**Bell Bend Nuclear Power Plant
Plot Plan Change Drawings WBS 1.4.1
BNP-2010-038 Docket No. 52-039**

Enclosed are hardcopy drawings and electronic versions of the revised Site Utilization Plot Plan (SUPP) that you requested. We are providing:

- a. SK-12198-400-001, Revision 2 – Reduced Scale SUPP
- b. SK-12198-400-002, Revision 2, Sheets 1 – 4, Full-scale SUPP

**SITE UTILIZATION
PLOT PLAN
SHEET 1 OF 4**

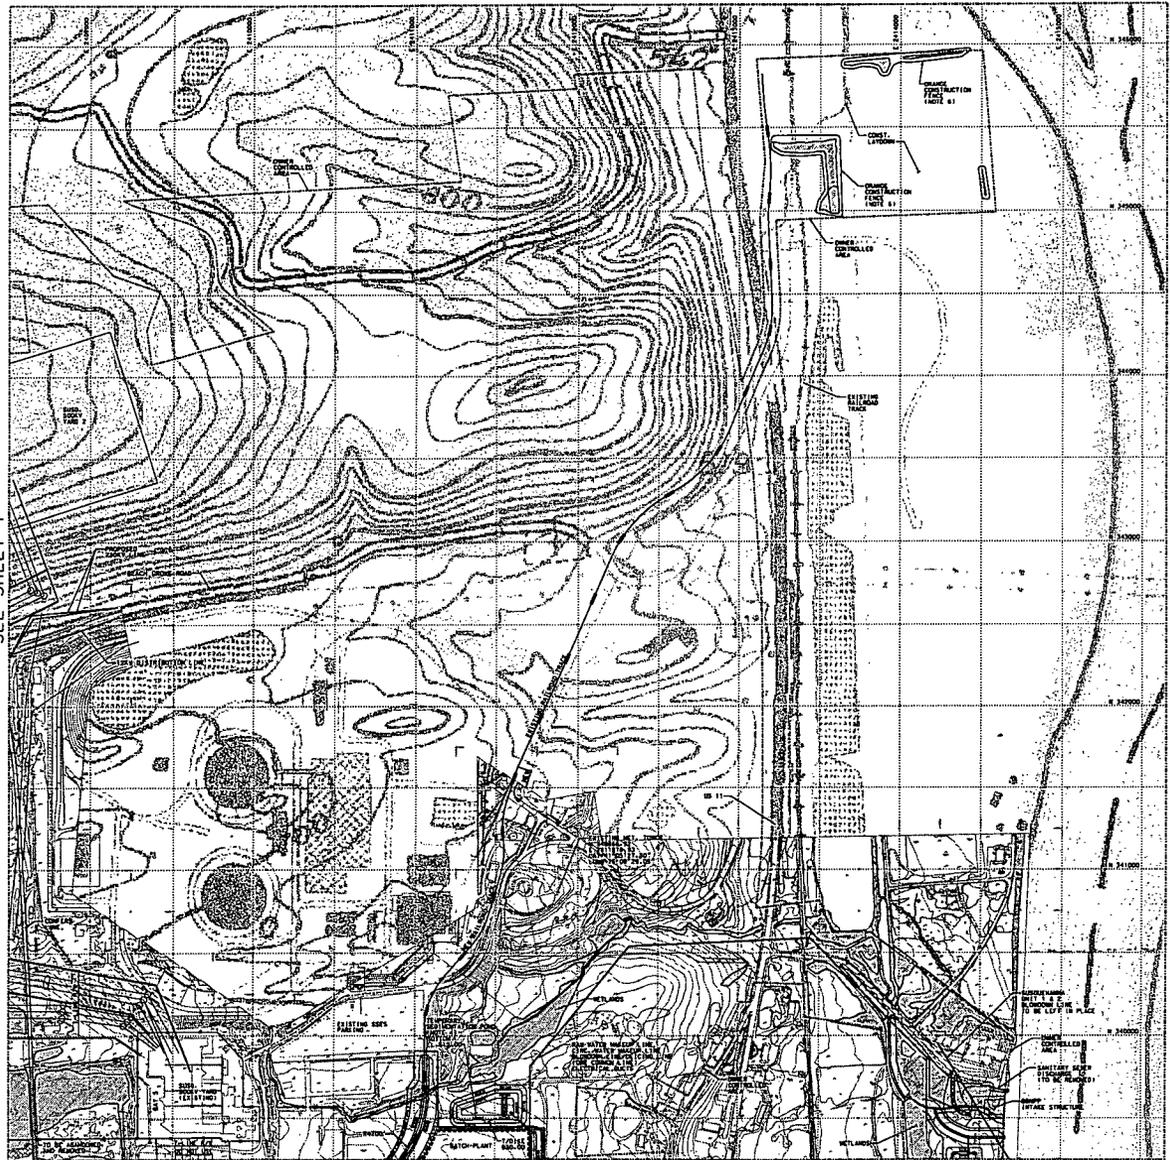
These drawings show the new location of the power block, approximately 1000 feet north and 300 feet west of the previous position, but still within the previous project boundary. This moves the power block out of the exceptional value wetlands and, pending final confirmation, will eliminate the need for dewatering. This move allowed us to greatly avoid and minimize overall wetland impacts, both temporary and permanent, and allows us to make greater use of infiltration Best Management Practices for stormwater control.

- SEE DRAWING SK-12198-400-001 FOR THE NAME AND SIZE OF NUMBERED BUILDINGS.
- THE CENTERLINE OF THE REACTOR BUILDING MOVED 972 FEET NORTH & 300 FEET WEST.
